ELECTRICAL SAFETY AUDIT REPORT

**Leading Food Industry
Ranjangaon, Pune**

Audit Period: 5th Dec 2016 to 20th Dec 2016

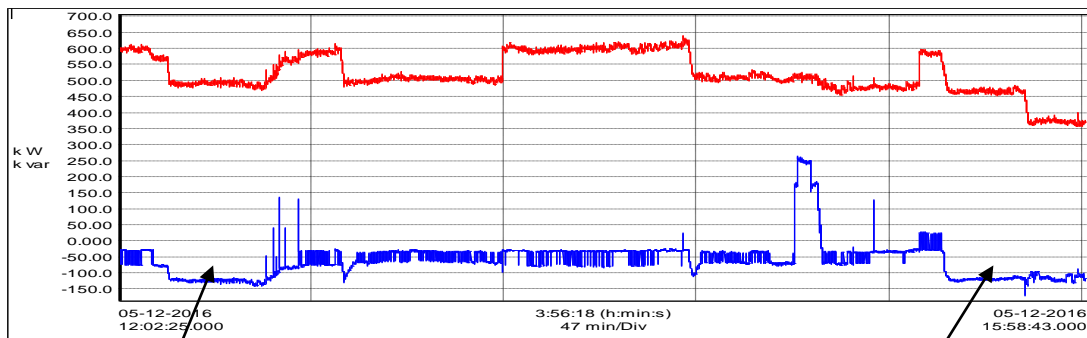
- This transformer is loaded up to 40%. The apparent loading is more as the transformer is handling large amount of current harmonics.
- At present reactive power requirement of the load on this transformer remains continuously over compensated. 50 to 150KVAR are extra on continuing basis. This is happening as 200KVAR fixed correction is connected in this case.

Over compensation happens when KW load is less due to fixed correction

- This is the reason **we see harmonic resonance** here at 5th harmonic current and total current distortion is reaches even 25%. The 5th harmonic current reduces to 25Amps from 125Amps when capacitors are OFF. (This would have reduced further while recording, but we could not simulate that situation as it was not possible to switch off fixed capacitors on this transformer.
- It is recommended that in long run, you should use automatic “Thyristor switched” detuned filter panels for power factor correction as well as harmonic mitigation.
- Maintaining unity power factor along with controlled current harmonics, will reduce transformer loss, associated temperature rise and will contribute in increasing transformer life.

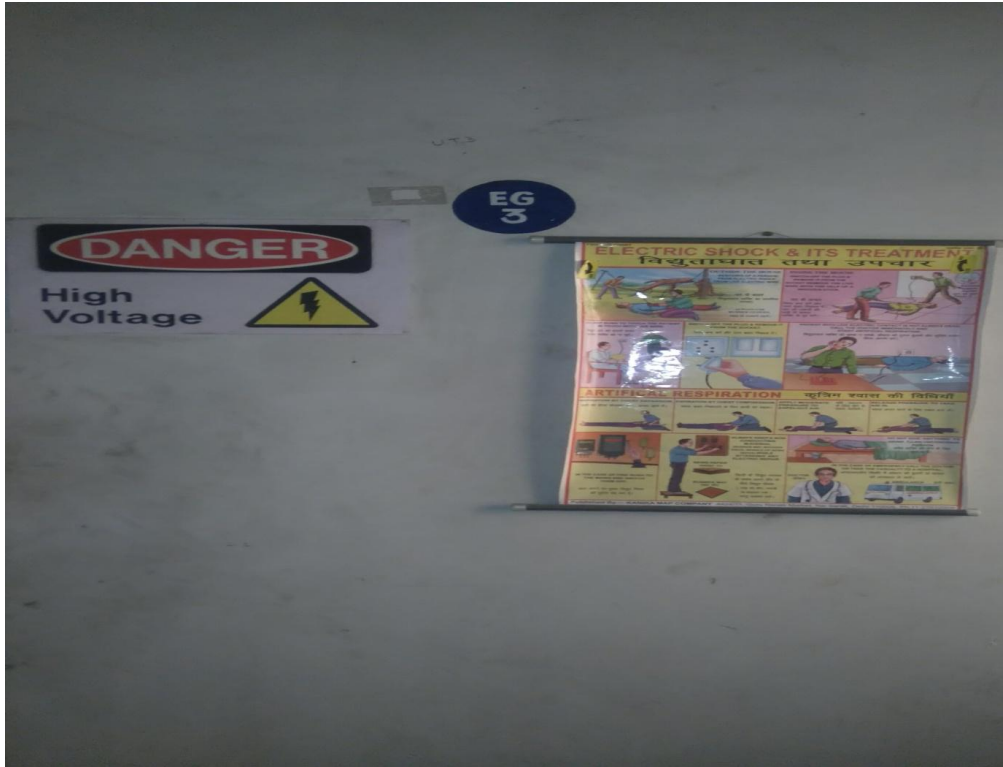
3) PPE use instructions are provided. It is advised that they should be provided in Hindi and Local Language as well. Following photograph shows availability of fire extinguisher. Please preserve test certificates for same.

- 4) Instructions for resuscitation are provided. Please provide danger signs in Hindi and local languages as well
